# Access Compliance Report

## Public Rights-of-Way

Intersection ID: 5600	Main Street: N_TRYON_ST	Cross Street: J_M_KEYNES_DR	Location: S
ADA ID: C21393A74AA2	Ramp Type: Perp	Initial Pass/Fail: Pass	Overall Compliance: No
Severity Score: 15.25			
Codes/Mitigation Info/Possible Solution		Field Measurements/Component Compliance

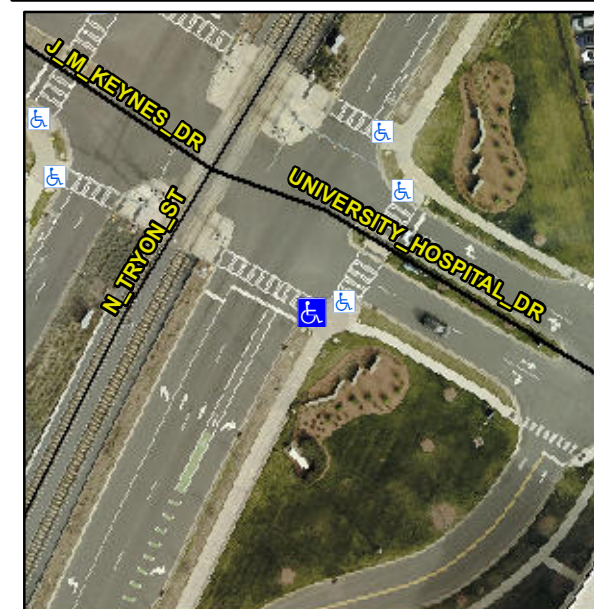
**R304.5.3, R302.7.2**

Compliance	Description	Data	Compliance	Description	Data
N/A	Ramp Length (in)	97.0	Yes	Ramp Slope (%)	6.8
Yes	Ramp Width (in)	48.0	No	Ramp XSlope (%)	2.9
N/A	Flare Type LT	Sloped	N/A	Flare Type RT	N/A
N/A	Flare Slope LT (%)	6.4	N/A	Flare Slope RT (%)	1.1
N/A	Flare Traversable LT?	Yes	N/A	Flare Traversable RT?	No
Yes	Landing Length (in)	95.0	Yes	DWS Provided?	Yes
Yes	Landing Width (in)	48.0	Yes	DWS Contrast?	Yes
Yes	Landing Slope (%)	1.5	Yes	DWS Length (in)	24.0
No	Landing X Slope (%)	3.9	Yes	DWS Full Width?	Yes
N/A	Landing Curb? (Y/N)	No	Yes	DWS Offset (in)	1.0
N/A	Shared Landing?	No			
Yes	Gutter Ponding?	No	Yes	Gutter Slope (%)	3.0
No	Gutter Lip Ht (in)	1.0	No	Gutter X Slope (%)	6.6
N/A	Painted X Walk1?	No	N/A	Painted X Walk2?	N/A
	X Walk 1 Direction	To NW		X Walk 2 Direction	N/A
N/A	X Walk 1 Width (in)	N/A	N/A	X Walk 2 Width (in)	N/A
	X Walk 1 Slope (%)	1.2		X Walk 2 Slope (%)	N/A
	X Walk 1 X Slope (%)	2.0		X Walk 2 X Slope (%)	N/A

**Remove & Replace Entire Ramp.  
Remove & Replace Gutter.**
